RENESAS TECHNICAL UPDATE

Product Category	MPU/MCU		Document No.	TN-RA*-A0003A/E	Rev.	1.00
Title	Errata for User's Manual: Hardware for SCE7		Information Category	Technical Notification		
Applicable Product	RA6M1 Group RA6M2 Group RA6M3 Group	Lot No.	Reference Document	RA6M1 Group User's Manual Hardware Rev.1.00 RA6M2 Group User's Manual Hardware Rev.1.00 RA6M3 Group User's Manual Hardware Rev.1.00		
		All

Figure 41.1 SCE7 block diagram

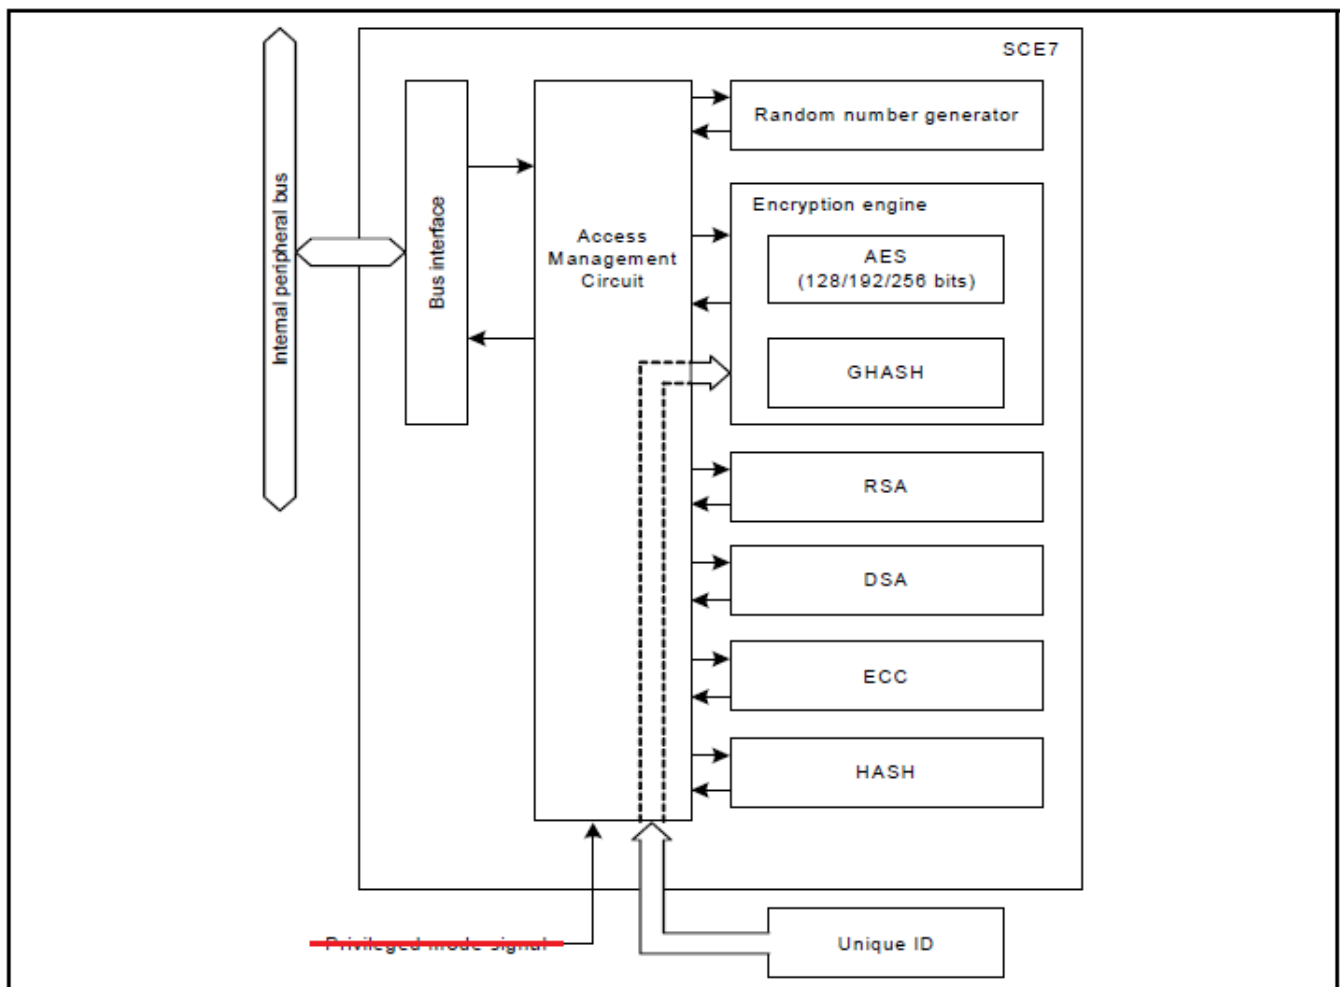
SCE7 is used in user mode and privileged mode. Therefore, the following descriptions should be deleted.

- In Table 41.1 SCE7 specifications, Privileged mode: The privileged mode signal is connected to the access management circuit and is used to limit control of the SCE7 module to privileged mode only.
- In Figure 41.1, Privileged mode signal.
